Well Name: BARN OWL FEDERAL	Well Location: T26S / R27E / SEC 19 / NWNE / 32.03555 / -104.224861	County or Parish/State: EDDY / NM
Well Number: 2H	Type of Well: OIL WELL	Allottee or Tribe Name:
Lease Number: NMNM114969	Unit or CA Name:	Unit or CA Number:
US Well Number: 3001542472	Operator: COG OPERATING LLC

Type of Submission: Notice of Intent	Type of Action: Plug and Abandonment
Date Sundry Submitted: 05/16/2024	Time Sundry Submitted: 08:05
Date proposed operation will begin: 06/01/2024

Procedure Description: Adding new wellbore diagrams for existing NOI per Long Vo.

## Proposed P&A SKETCH

## Barn Owl Federal No. 2H

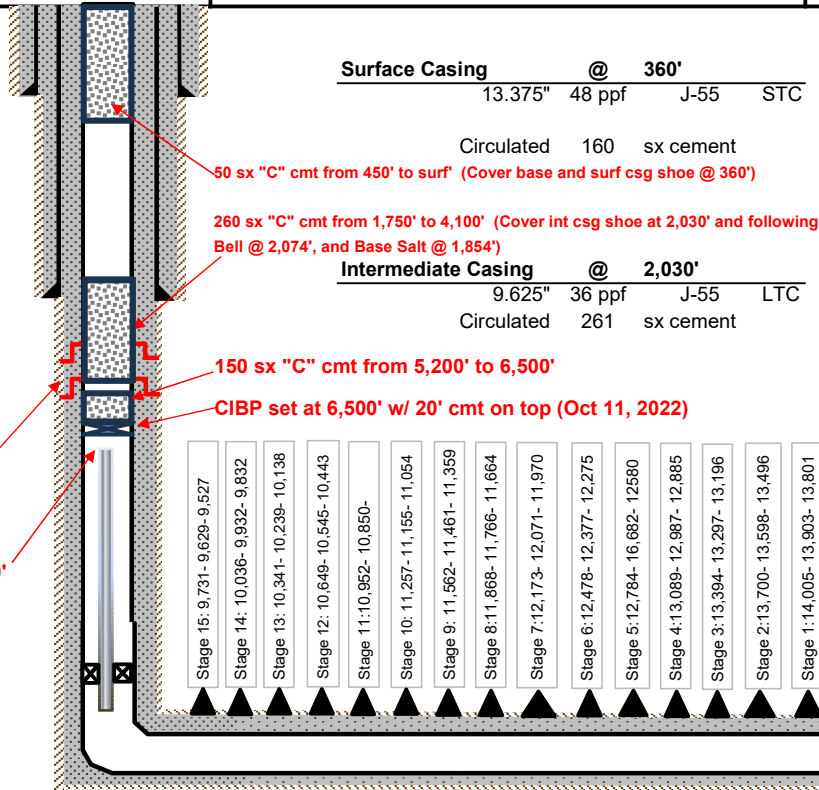
~~50 sx "C" cmt from 450' to surf' (Cover base and surf csg shoe @ 360')~~

260 sx "C" cmt from 1,750' to 4,100' (Cover int csg shoe at 2,030' and following tops: Brushy @ 4,041', Cherry @ 2,930', Bell @ 2,074', and Base Salt @ 1,854')

**150 sx "C" cmt from 5,200' to 6,500'**

~~CIBP set at 6,500' w/ 20' cmt on top (Oct 11, 2022)~~

## CURRENT WELL SKETCH

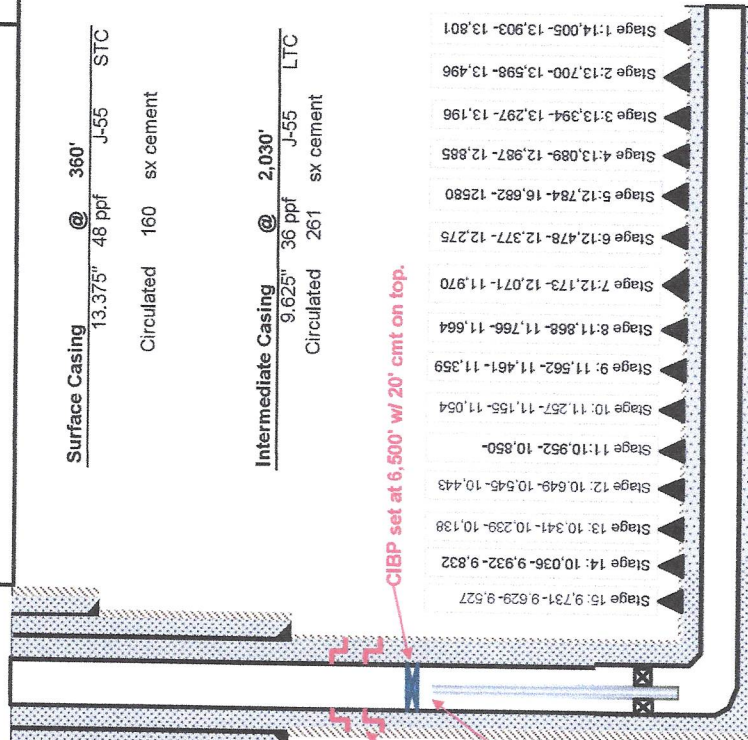
Verify cement across all casing.

260 sx "C" cmt from 1,750' to 4,100' (Cover Int csg slope at 2,030' and following tops: Brushy @ 2,930', Bell @ 2,074', and Base Salt @ 1,854') **woc & TAG**

Intermediate Casing @ 2,030' *woc & TAC*

150 sx "C" cmt from 5,200' to 6,500'      woc & TAG @ 5523'      Leak test CIBP.

13.375 inch- Shoe Plug	306.40	410.00	103.60	Tag/Verify	50.00	C	Spot cement from 450' to surface. Verify at surface.
Base of Salt @ 1854	1785.46	1904.00	118.54	Tag/Verify

9.625 inch- Shoe Plug	1959.70	2080.00	120.30	Tag/Verify			
Delaware @ 2074	2003.26	2124.00	120.74	If solid			
Casing Repair @ 2706	2628.94	2756.00	127.06	If solid			
				If solid base no need to Tag (CIBP present and/or Mechanical Integrity Test), If Perf & Sqz then Tag, Leak Test all CIBP if no Open Perforations			Spot cement from 4100' to 1469'. WOC and Tag.
Casing Repair @ 2750	2672.50	2800.00	127.50		260.00	C	
Bonesprings @ 5630	5523.70	5680.00	156.30	If solid			
				If solid base no need to Tag (CIBP present and/or Mechanical Integrity Test), If Perf & Sqz then Tag, Leak Test all CIBP if no Open Perforations			Tag CIBP and spot 150 sxs on top. Leak test CIBP. WOC and Tag @ 4982'.
CIBP Plug	6465.00	6500.00	35.00	ns	150.00	C
